STAFF REPORT

DATE: 04/06/2021

TO: Mayor and City Council
FROM: Ben Prchal, City Planner
AGENDA ITEM: **The Legacy at North Star Fourth Addition – Easement Vacation, Final Plat and PUD Plans**
REVIEWED BY: Ken Roberts, Planning Director

LEGACY AT NORTH STAR 4TH ADDITION

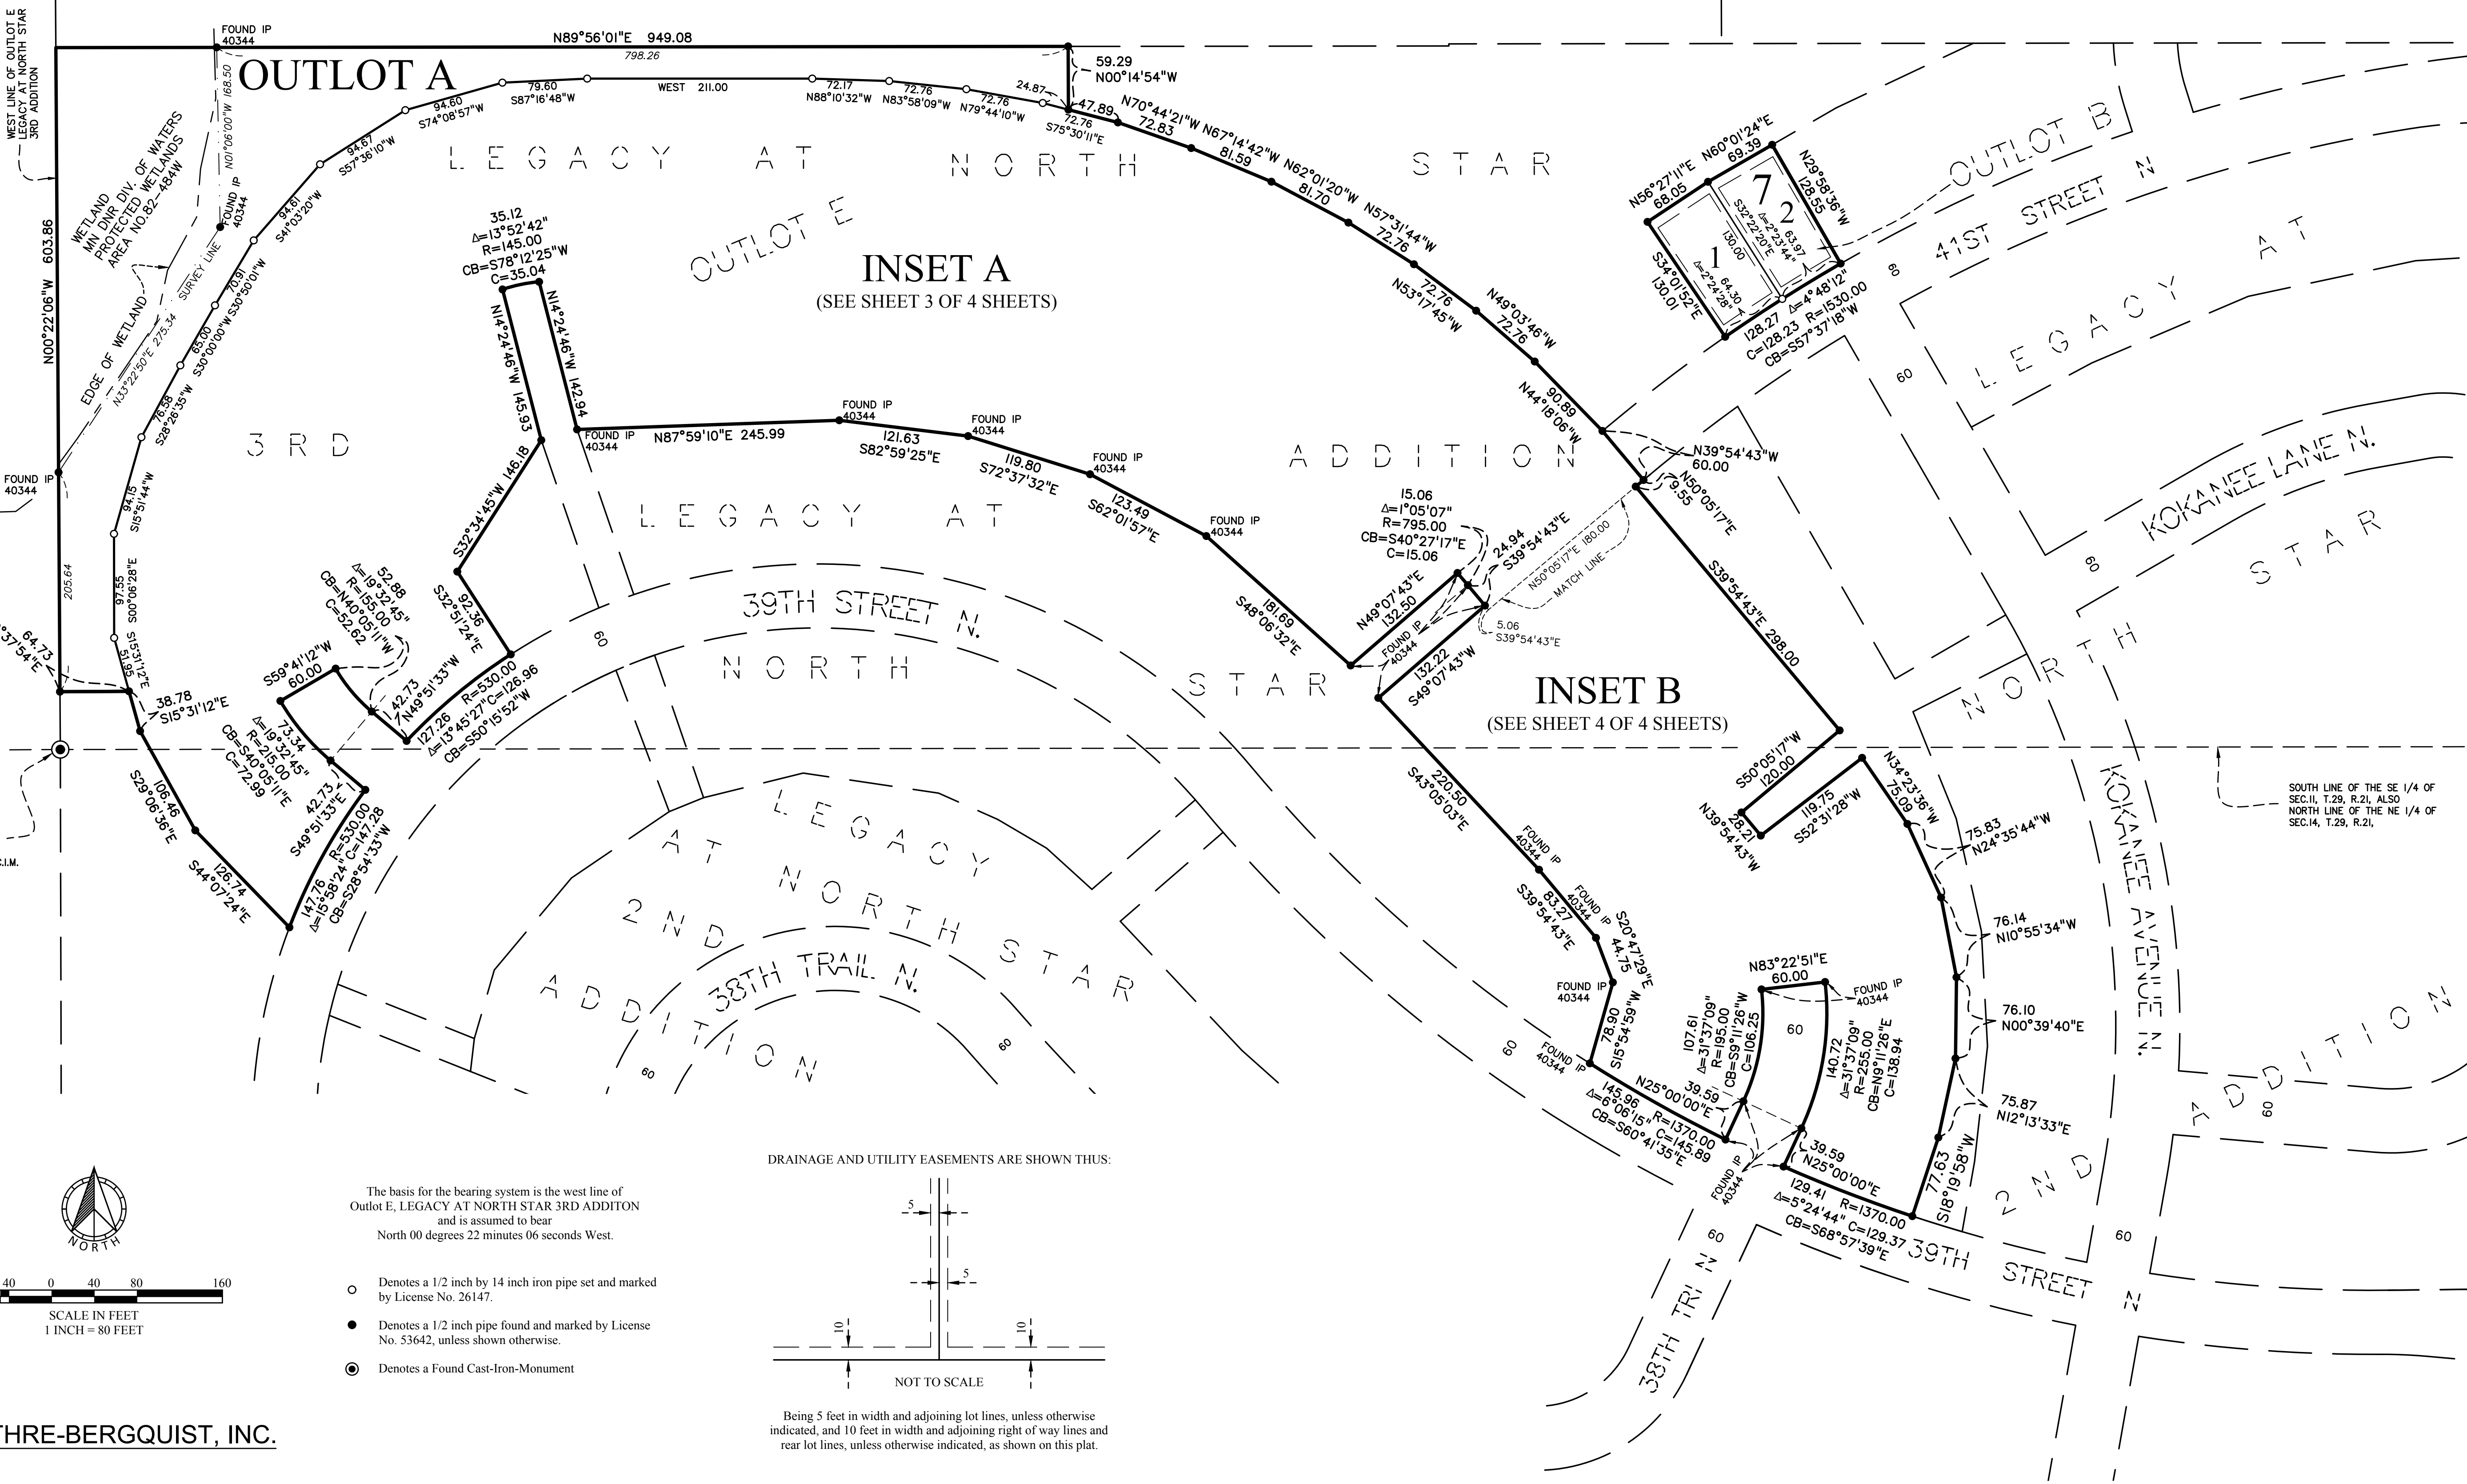
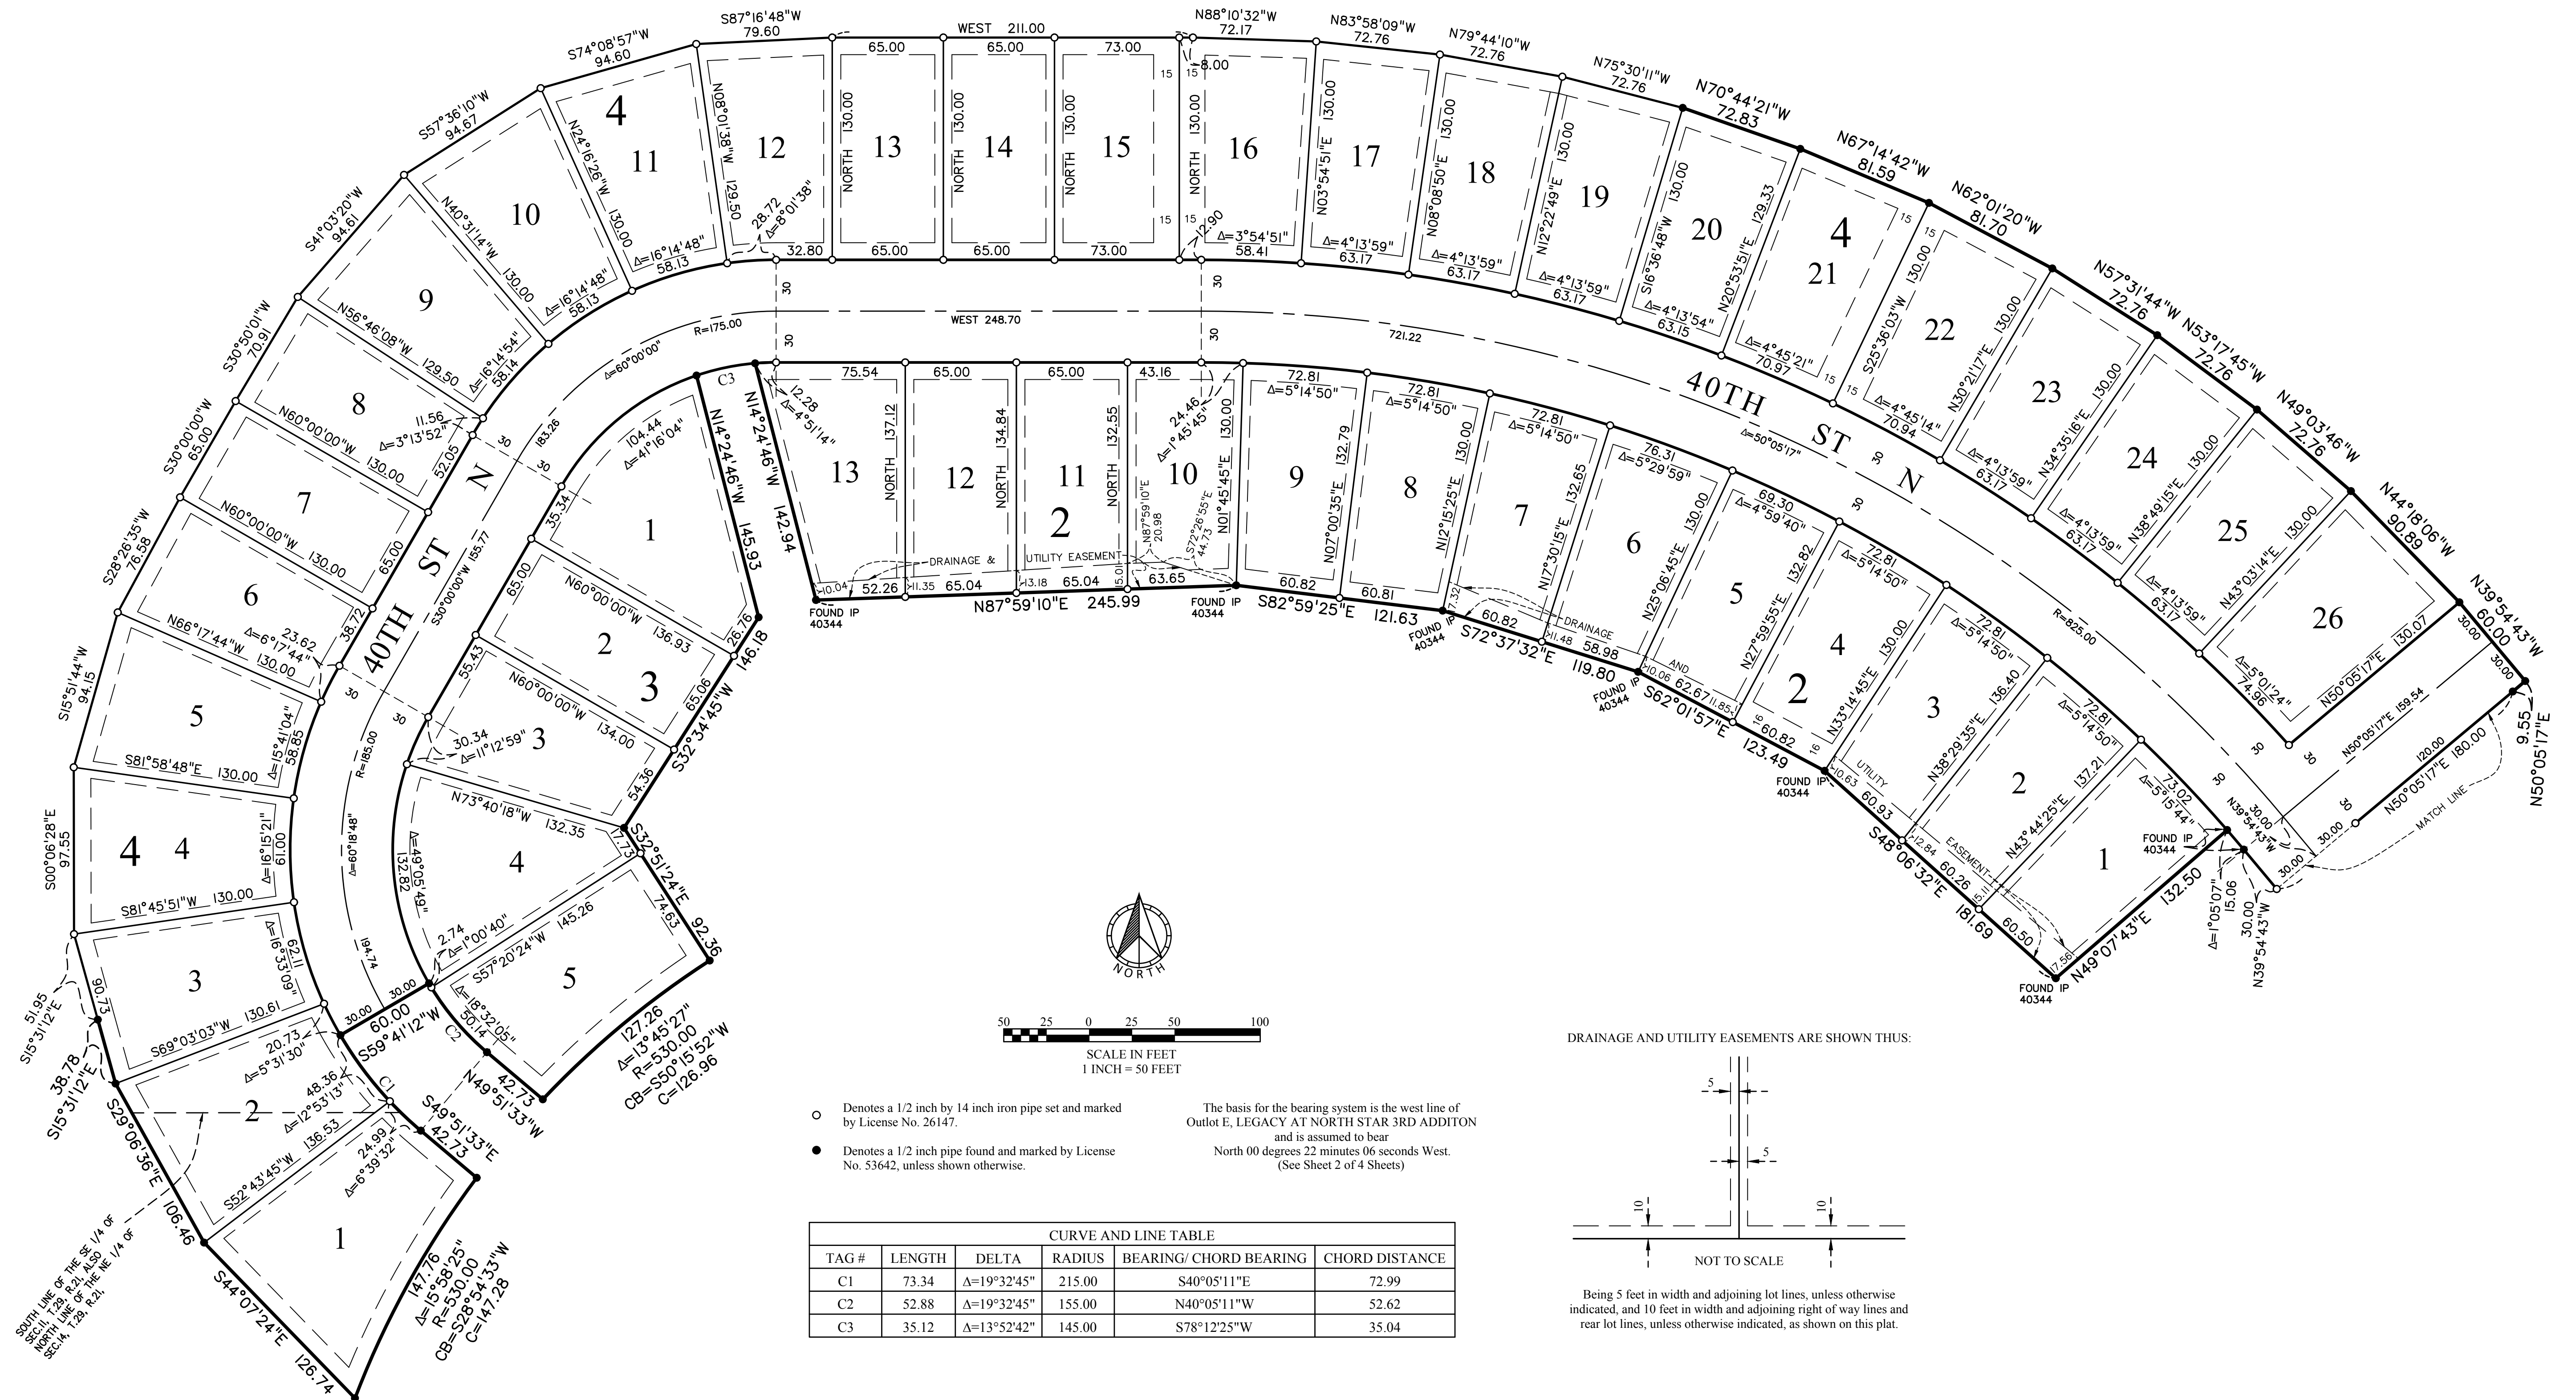
- Outlot A is shown as City owned on the Plans. This must be revised on the Plans to be HOA owned with a drainage and utility easement over all of Outlot A.

- All easements as requested by the City Engineer and Public Works department shall be documented on the Final Plat prior to the release of the Final Plat for recording. The Final Plat must be revised to show a drainage and utility easement over all of Outlot A.

- The rear yard lot easement must be revised on the Plat and Plans for Lot 10, Block 2. The easement should be a straight line while containing the localized HWL within the easement area.
